## Haldex Full Function ABS (FFABS) Tank Mounting Nipple No Longer Supplied With Pre-Applied Sealant

### Reservoir Port Nipple 1/2" NPT and 3/4" NPT

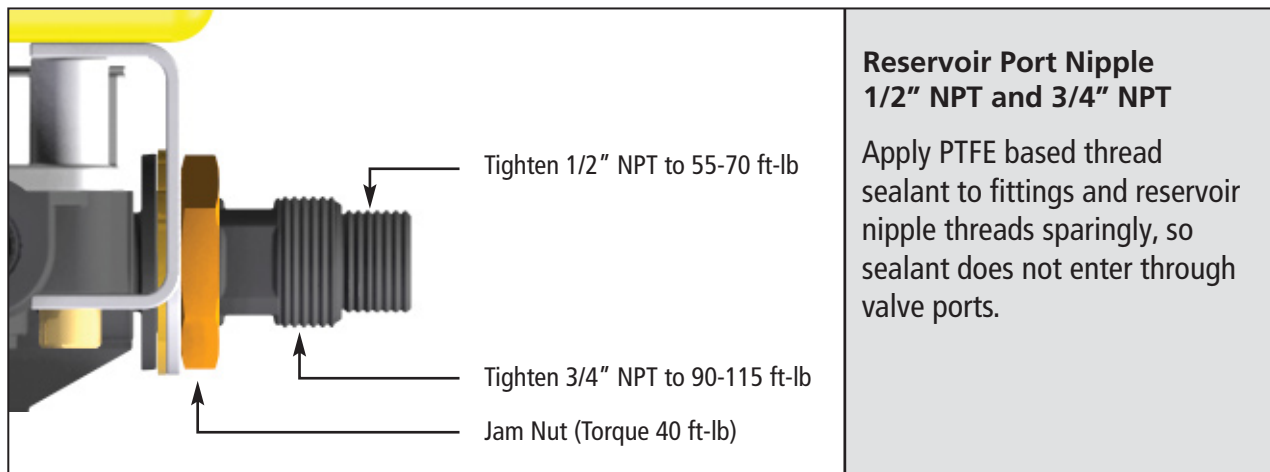
Effective immediately, Haldex will begin shipping all Full Function ABS (FFABS) products that include a tank mounting nipple without a pre-applied sealant. This change is being made to allow for customer preferences in installation including, sealant manufacturer and timing of application. This will be treated as a running change and will result in no affect in fit, form or function of FFABS products.

Apply PTFE based thread sealant to fittings and reservoir nipple threads sparingly, so sealant does not enter through valve ports.
